**RE: Evangel Christian Center
4501 Montgomery NE
Grading and Drainage Plan
Engineer's Stamp Date: 12/13/19
Hydrology File: F17D007**

Based upon the information provided in your submittal received 12/19/2019, the Grading & Drainage Plan is approved for Building Permit and Grading Permit.

SHEET C-100

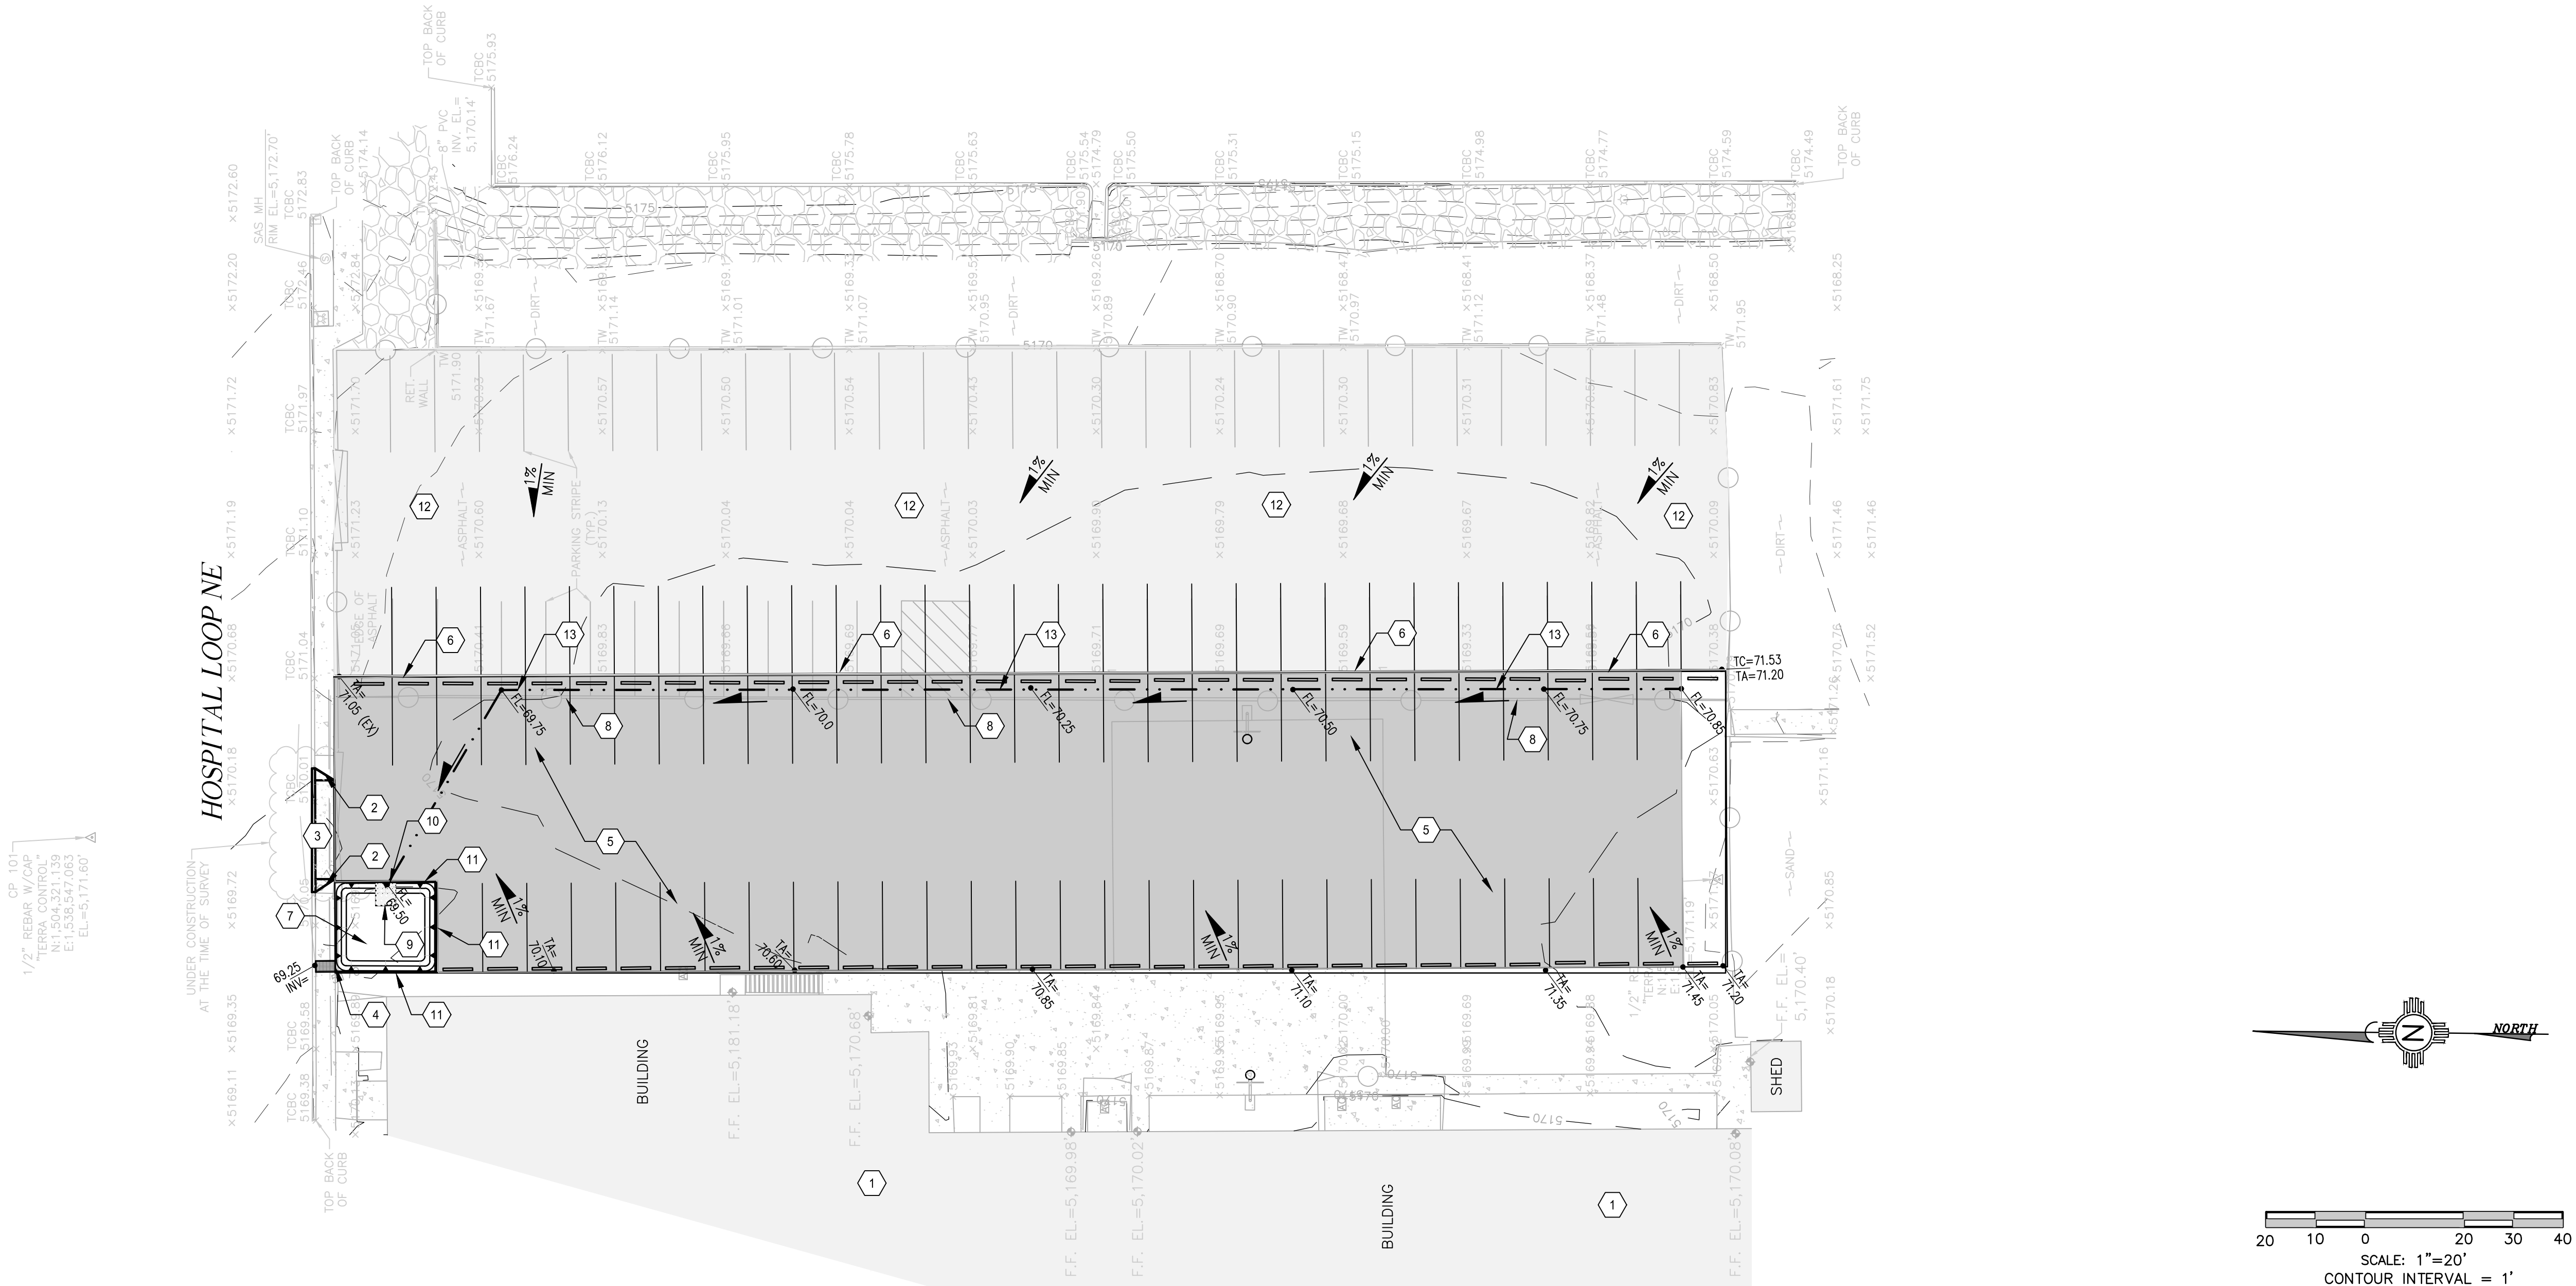
Please attach a copy of this approved plan in the construction sets for Building Permit processing along with a copy of this letter. Prior to approval in support of Permanent Release of Occupancy by Hydrology, Engineer Certification per the DPM checklist will be required.

Also as a reminder, please provide a Drainage Covenant for the proposed stormwater quality pond per Chapter 17 of the DPM prior to Permanent Release of Occupancy. Please submit this on the 4th floor of Plaza de Sol. A \$25 fee will be required.
